SUBJECT: FUEL TANK FILLER CAP AND ADAPTER ASSEMBLY, MODIFICATION TO REMOVE O'RING FROM LOWER SEALING FLANGE

MODEL/S/N AFFECTED: Mooney M20K, S/N 25-0001 THRU 25-1213

FIGURE SI M20-84-1

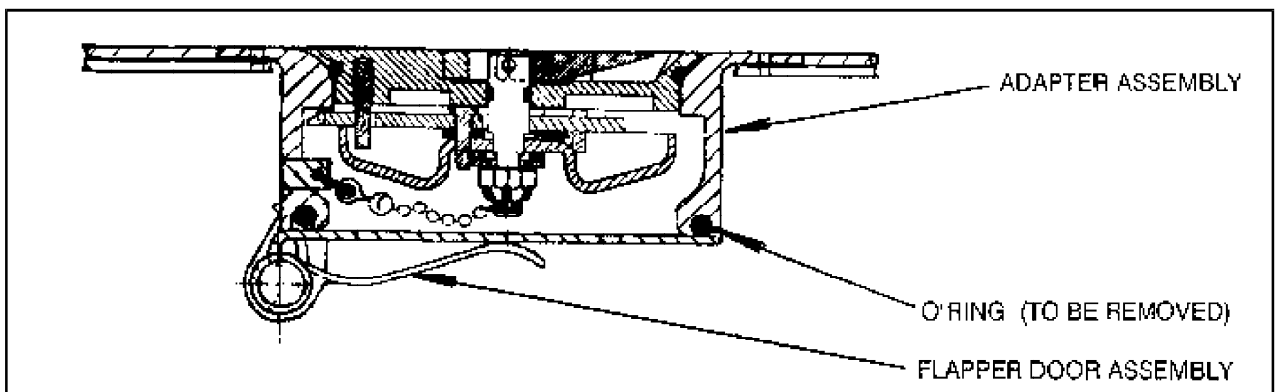
INTRODUCTION: Field reports have been received of aircraft landing after flights at high altitude where fuel tank caps are very difficult to remove for refueling purposes. This is suspected to be caused by vacuum forming between the filler cap and the flapper door assembly in the fuel cap adapter assembly.

To eliminate this condition, it is authorized to remove the O'ring from the lower sealing surface of the adapter assembly if desired.

1. This procedure should not be attempted when fuel tanks are more than 3/4 full.
2. Remove fuel tank filler cap assembly; leave attached to lanyard.
3. Push flapper door assembly down and wedge it in the open position with any suitable non-metallic item. Place restraint on wedge used so that it can be recovered if dropped inside tank.
4. Using a sharp, curved pick, ie., dental tool, or similar device remove O'ring that is installed in a groove on the bottom surface of the adapter assembly (Refer to Figure SIM20-84-1).
BE CAREFUL THAT THE REMOVED O'RING DOES NOT FALL DOWN INTO THE FUEL TANK.
5. Repeat steps 1. through 4. on other tank.
6. Re-install fuel filler cap assembly on both tanks
7. Enter compliance data into aircraft logbook and return aircraft to service.
